Re: Application for improvement permit for: 4 Bedroom House
Property Location: 5128 Lakeview Rd, Charlotte, NC 28216 (PID 037-162-13)
Health Department File Number: **10329B (App ID 10502)**

Sheet: 1 of 2
Property ID: 037-162-13
Lot #: 23
File #: 10329B
AppID: 10502

SOIL/SITE EVALUATION
for ON-SITE WASTEWATER SYSTEM

PROPOSED PLOT PLAN

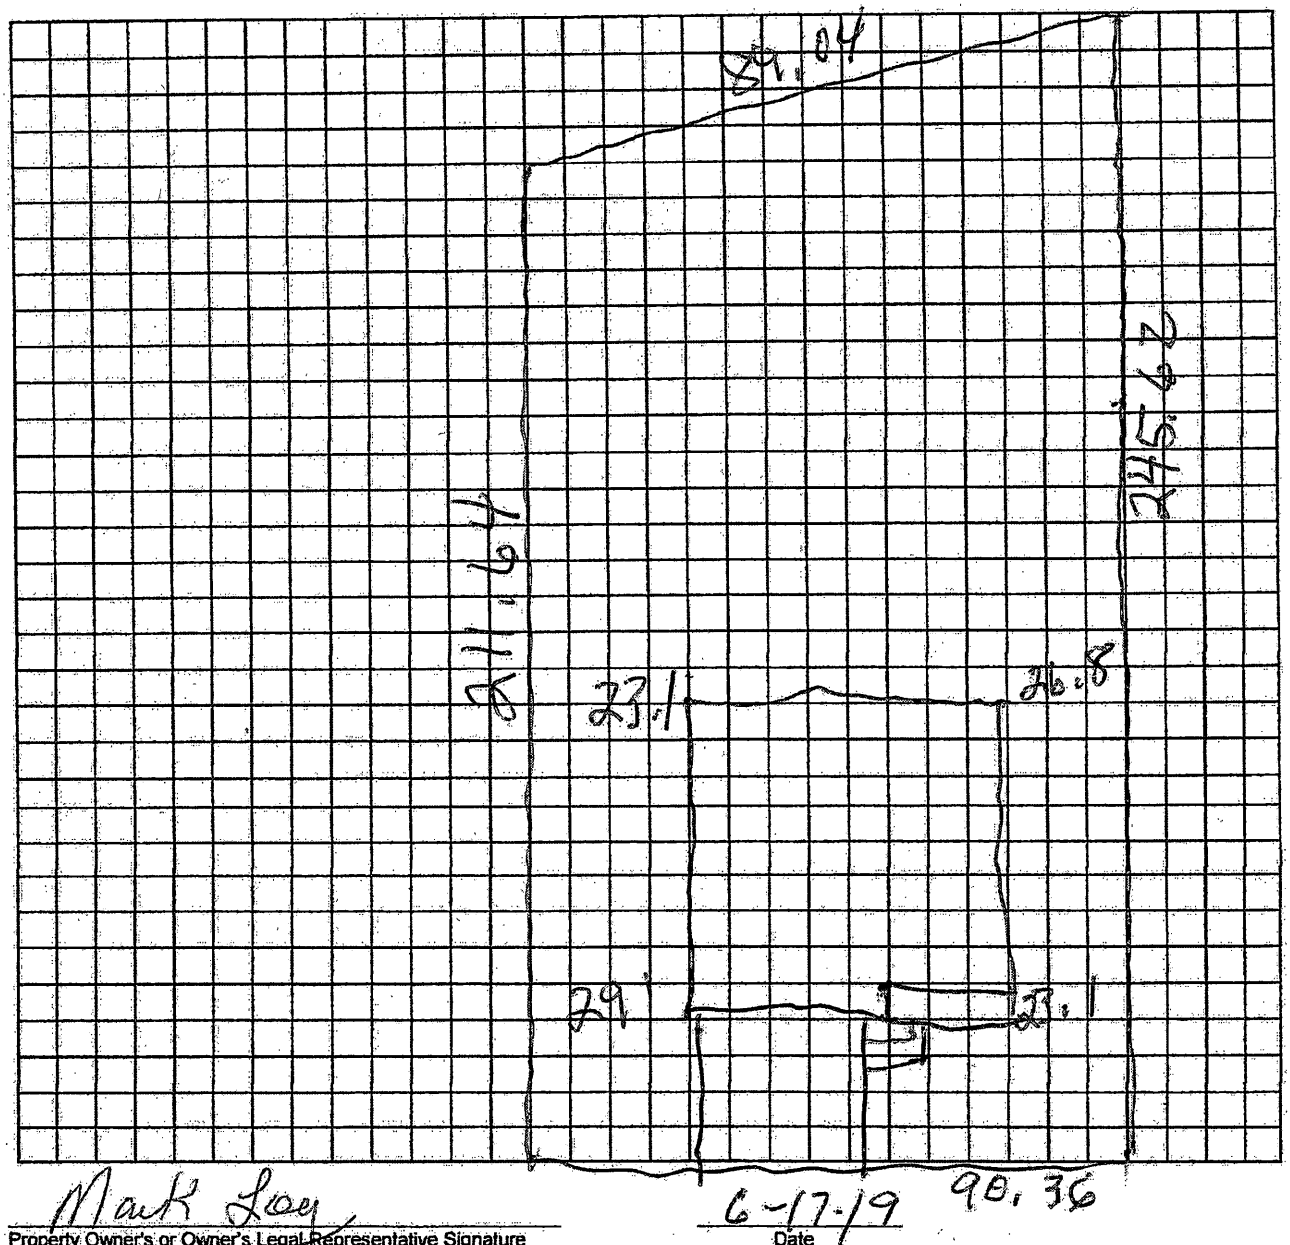
Based on the criteria set out in Title 15A, Subchapter 18A, of the North Carolina Administrative Code, Rules .1940 through .1948, the evaluation indicated that the site is **UNSUITABLE** for a ground absorption sewage system. Therefore, your request for an improvement permit is **DENIED.** A copy of the site evaluation is enclosed. The site is unsuitable based on the following:

- ☐ Unsuitable soil topography and/or landscape position (Rule .1940)
- ☐ Unsuitable soil characteristics (structure or clay mineralogy) (Rule .1941)
- ☒ Unsuitable soil wetness condition (Rule .1942)
- ☒ Unsuitable soil depth (Rule .1943)
- ☐ Presence of restrictive horizon (Rule .1944)
- ☒ Insufficient space for septic system and repair area (Rule .1945)
- ☐ Unsuitable for meeting required setbacks (Rule .1950)
- ☐ Other (Rule .1946)

However, the site classified as **UNSUITABLE** may be classified as **PROVISIONALLY SUITABLE** if written documentation is provided that meets the requirements of Rule .1948(d). A copy of this rule is enclosed. You may hire a consultant to assist you if you wish to try to develop a plan under which your site could be reclassified as **PROVISIONALLY SUITABLE.**
